### **4.3 Side-by-Side Responses to Comments**

This section includes the comment letters received during the public review period (May 29, 2020, to July 13, 2020) for the Draft Revised EIR and the City of Santee's responses to these comments.

## Comment Letter F1: U.S. Fish and Wildlife Service, July 13, 2020

Subject: Comments on the Draft Revised Environmental Impact Report for the Fanita Ranch Project, City of Santee, San Diego County, California

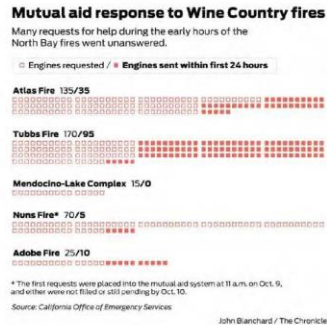
*"During a large, regional wildfire, the City assures response from its fire stations, including the on-site station. During a large wildfire, there would be several or more fire agencies providing resources including CAL FIRE with its full complement of ground and aerial attack capabilities. San Diego County includes a significant wildfire response resource with equally as significant experience pre-planning, coordinating, and attacking wildfires that would all be available to the Project area, as needed."* [FPP 2020 p. 99]

This is another reversal from FPP 2007 [AR 018511, 12].

**07-34:** This comment appears to be referencing a graphic titled “Mutual Aid Response to Wine County Fires.” This comment does not raise a significant environmental issue regarding the adequacy or accuracy of the information provided in the EIR. Therefore, no further response is required.

Figure 1-4  
MSCP Multiple Habitat Planning Areas (MHPA)  
Santee MSCP Subarea Plan

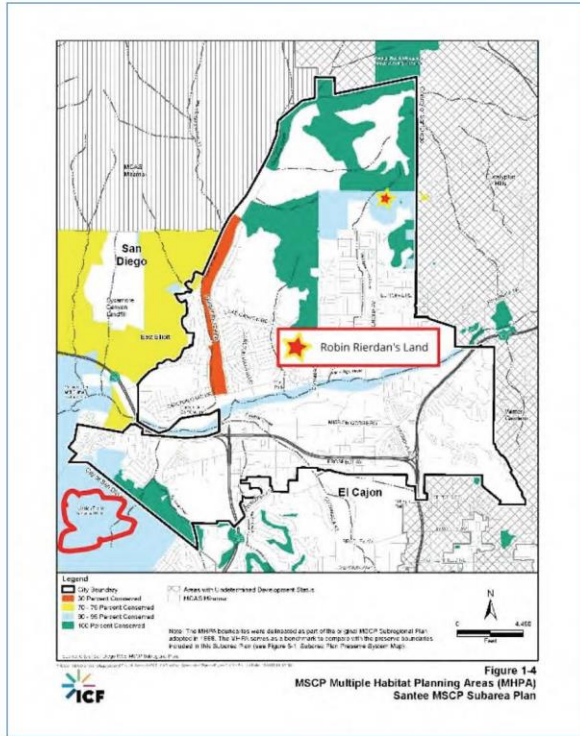
Please note that this map indicates that our property will be entirely conserved in the same way that Mission Trails Regional Park is conserved. Imagine my surprise to see this. I object to this on the following grounds.

It should be noted that the commenter's property may be included in the Santee MSCP Subarea Plan boundary, but in no way is there a statement being made by the project's EIR document that concludes that the commenter's property would be conserved in the same way as Mission Trails Regional Park.

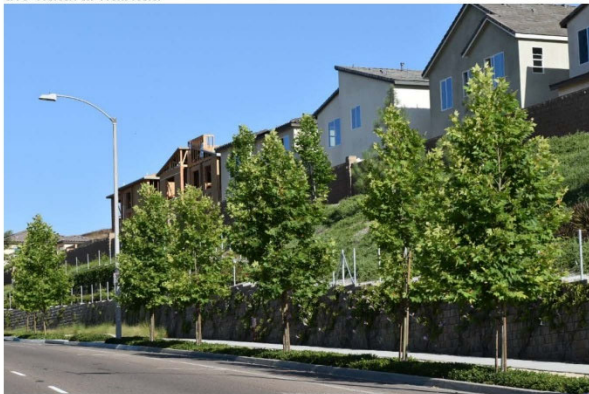
I'll begin at the end. This is the existing end of the Weston Trail that is pending completion. You can see the wood post fence along the trail and the new plantings. The natural habitat is to the right and above the trail in this photo. This is what the hillside looked like for as long as I can remember. The trees in the foreground are on the Santee Lakes Preserve and Campground.

**I121-2:** This comment includes photographs of the trail built by the Weston project with descriptions provided as an attachment by the commenter. This comment does not raise a significant environmental issue regarding the adequacy or accuracy of the information provided in the EIR. Therefore, no further response is required.
